Technical Service Bulletin

SUBJECT:		No: TSB-19-52B-006	
CORRECTIONS TO SRS AIR BAG DIAGNOSIS FOR DTC B1631 - SERVICE MANUAL REVISION		DATE: June 2019	
		MODEL: 2011-18 Outlander Sport/RVR	
CIRCULATE TO:	<input type="checkbox"/> GENERAL MANAGER	<input checked="" type="checkbox"/> PARTS MANAGER	<input checked="" type="checkbox"/> TECHNICIAN
<input checked="" type="checkbox"/> SERVICE ADVISOR	<input checked="" type="checkbox"/> SERVICE MANAGER	<input type="checkbox"/> WARRANTY PROCESSOR	<input type="checkbox"/> SALES MANAGER

Please make the indicated changes to the 2011 - 2018 Outlander Sport/RVR Service Manuals, Group 52B-Supplemental Restraint System (SRS) -> SRS Air Bag Diagnosis -> Diagnostic Trouble Code Procedures -> DTC B1631: Driver's Knee Air Bag (Squib) System (Short Circuit Between Squib Circuit Terminals):

STEP 3. Check SRS-ECU connector C-126 and Knee air bag module connector C-223.

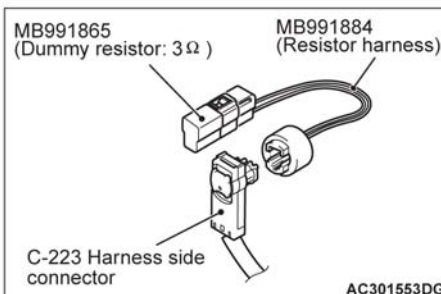
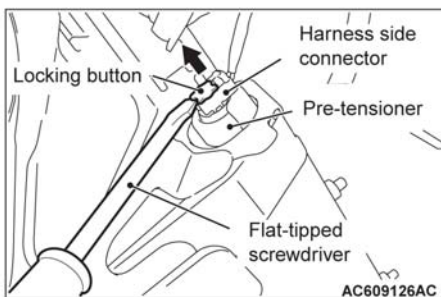
- (1) Disconnect the negative battery terminal.
- (2) While pushing the part "A" indicated in the figure of the harness side connector, turn the lock lever to the direction of the arrow to release the lock lever. After disconnecting the C-126 SRS-ECU connector, connect it again.

- (3) Disconnect C-223 driver's knee air bag module harness side connector, and then reconnect it. Use a flat-tipped screwdriver to pull out the connector locking button toward the arrow direction, release the lock, and then disconnect the connector.
